Access Compliance Report

Public Rights-of-Way

(Curb Ramps)

Intersection ID: 25536	Main Street: CARPENTER_DR	Cross Street: QUAIL_RIDGE_DR	Location: SE
ADA ID: 4EFBF9B5E3A0	Ramp Type: PerpDiag	Initial Pass/Fail: Fail	Overall Compliance: No
		Severity Score: 25

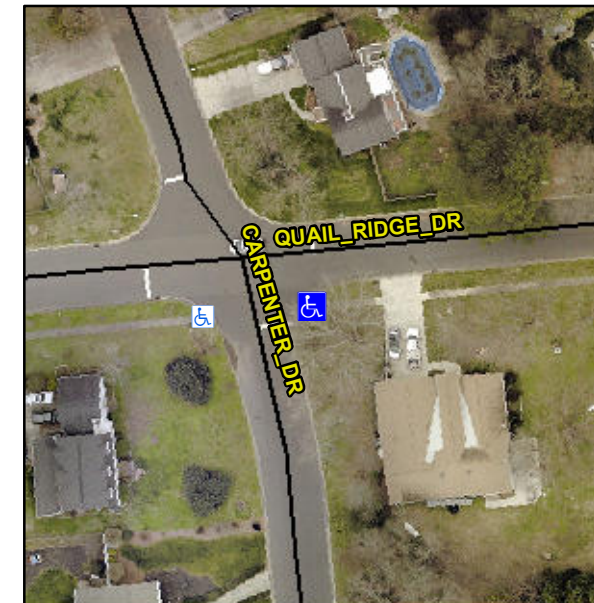
Not Found, R304.5.3

Compliance	Description	Data	Compliance	Description	Data
N/A	Ramp Length (in)	27.0	Yes	Ramp Slope (%)	6.5
Yes	Ramp Width (in)	50.0	No	Ramp XSlope (%)	13.4
N/A	Flare Type LT	N/A	N/A	Flare Type RT	N/A
N/A	Flare Slope LT (%)	N/A	N/A	Flare Slope RT (%)	N/A
N/A	Flare Traversable LT?	N/A	N/A	Flare Traversable RT?	N/A
N/A	Landing Length (in)	N/A	N/A	DWS Provided?	N/A
N/A	Landing Width (in)	N/A	N/A	DWS Contrast?	N/A
N/A	Landing Slope (%)	N/A	N/A	DWS Length (in)	N/A
N/A	Landing X Slope (%)	N/A	N/A	DWS Full Width?	N/A
N/A	Landing Curb? (Y/N)	N/A	N/A	DWS Offset (in)	N/A
N/A	Shared Landing?	N/A			
N/A	Gutter Ponding?	N/A	N/A	Gutter Slope (%)	N/A
N/A	Gutter Lip Ht (in)	N/A	N/A	Gutter X Slope (%)	N/A
N/A	Painted X Walk1?	No	N/A	Painted X Walk2?	No
	X Walk 1 Direction	To N		X Walk 2 Direction	To W
N/A	X Walk 1 Width (in)	N/A	N/A	X Walk 2 Width (in)	N/A
	X Walk 1 Slope (%)	4.3		X Walk 2 Slope (%)	10.8
	X Walk 1 X Slope (%)	12.4		X Walk 2 X Slope (%)	2.3

Remove & Replace Curb Ramp With Two New Directional Ramps or Equivalent.
